# Government Land Standing Advisory Committee

## Tranche 16 Report

### 419 – 421 Upper Heidelberg Road, Ivanhoe

1 June 2018

**Figure 4: DPO Concept Plan tabled at the Hearing**

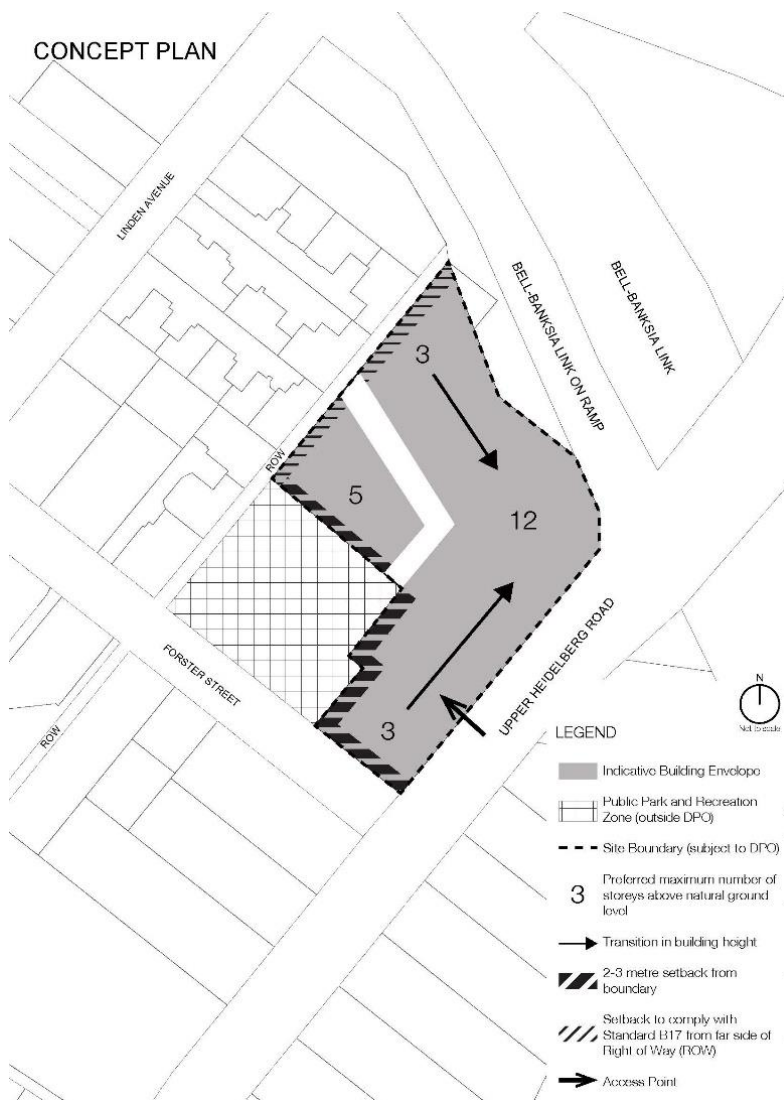
The site owner proposed the inclusion of a concept plan to the DPO (Figure 4) to illustrate the development envelopes for the site. The site owner submitted that the Concept Plan adequately represented the masterplan discussed with the community in the two stage consultation.

Council submitted that the tabled concept plan does not give sufficient clarity on height transition and that sections should be included to demonstrate this. Council submitted that the concept plan should limit building height to three storeys at the interface with Forster Street, the park and the Right of Way. Further, Council submitted that the building height at the north-eastern and eastern edges of the proposed park should be limited to prevent overshadowing of the park.

Council submitted that the DPO should contain built form requirements including that the development plan must describe building heights that do not exceed the height limits, setbacks and site coverage nominated in DPO7. The tabled concept plan nominates the heights as *“preferred maximum number of storeys above natural ground”*.

The tabled concept plan included a setback of two to three metres from Forster Street and the proposed park. The concept plan included a note that buildings should comply with Standard B17 setbacks from the far side of the Right of Way. Council submitted that the concept plan should require a five metre minimum setback to Forster Street, the park and the Right of Way. Council based its submission for increased setbacks on the masterplan from those that the site owner presented to the community as part of the community consultation.

The tabled concept plan nominated an Access Point on Upper Heidelberg Road. Council submitted that the DPO should nominate that car access is only permitted from Upper Heidelberg Road (no vehicle access from Forster Street) and that parking should be at the basement level.

#### Concept Plan

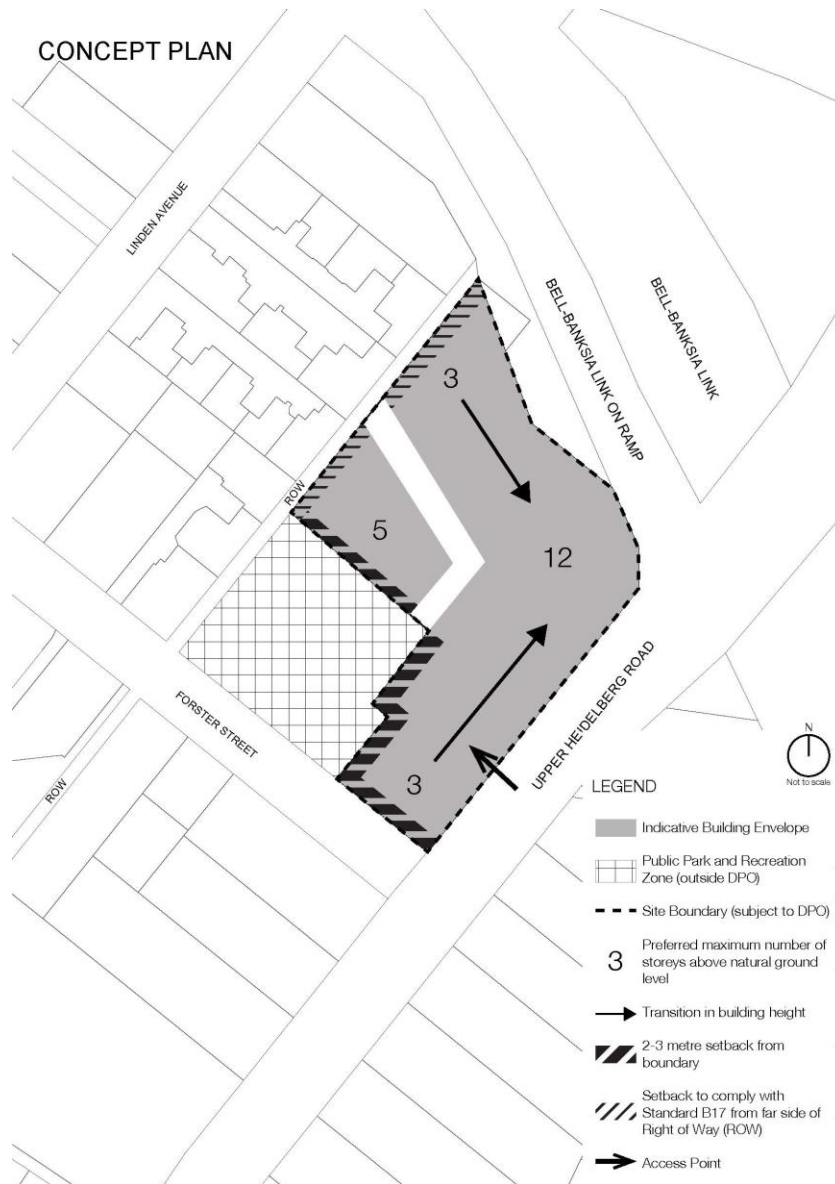
\*\*\*The Committee recommends that the Concept Plan be amended to show:

Remove the word 'Preferred' from the legend relating to building height

Change the 2-3 metre setback with 5 metres to Forster Street and the Right of Way

Change wording 'from far side of' to eastern side of Right of Way
